Docket No. 50-302	DISTRIBUTION	JNGrace
$\langle$	Docket File	WJones
	NRC PDR	DBrinkman
	L PDR	RDiggs
Mr. Walter S. Wilgus	ORB#4 Rdg	RIngram
Vice President, Nuclear Operations	DEisenhuť	ADe Agazio
Florida Power Corporation	OELD	Gray File+4
ATTN: Manager, Nuclear Licensing	CMiles	EBlackwood
& Fuel Management	LHarmon	HOrnstein
Post Office Box 14042, M.A.C. H-2	ACRS-10	
St. Petersburg, Florida 33733	TBarnhart-4	
•••	HDenton	
Dear Mr. Wilgus:	EJordan	
Ū.	Division of Licens	ing
The Commission has issued Amendment	t No. <sup>69</sup> to Facility	y Õperating L

The Commission has issued Amendment No. <sup>69</sup> to Facility Operating License No. DPR-72 for the Crystal River Unit No. 3 Nuclear Generating Plant (CR-3). The amendment consists of changes to the Technical Specifications (TSs) in response to your application dated January 17, 1983, as revised on November 1 and December 16, 1983, and March 22, 1984.

#### CRYSTAL RIVER UNIT 3 NUCLEAR GENERATING PLANT

#### AMENDMENT TO FACILITY OPERATING LICENSE

MAP DEFINING UNRESTRICTED AREAS FOR RADIOACTIVE GASEOUS AND LIQUID EFFLUENTS

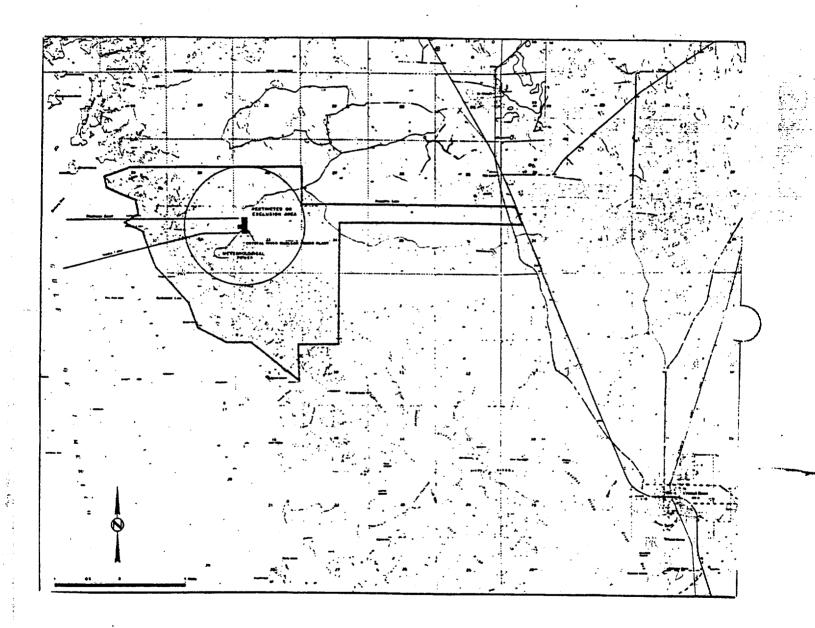
5.1.3 Information regarding radioactive gaseous and liquid effluents, which allows identification of structures and release points as well as definition of UNRESTRICTED AREAS within the SITE BOUNDARY that are accessible to MEMBERS OF THE PUBLIC, shall be as shown in Figure 5.1-3.
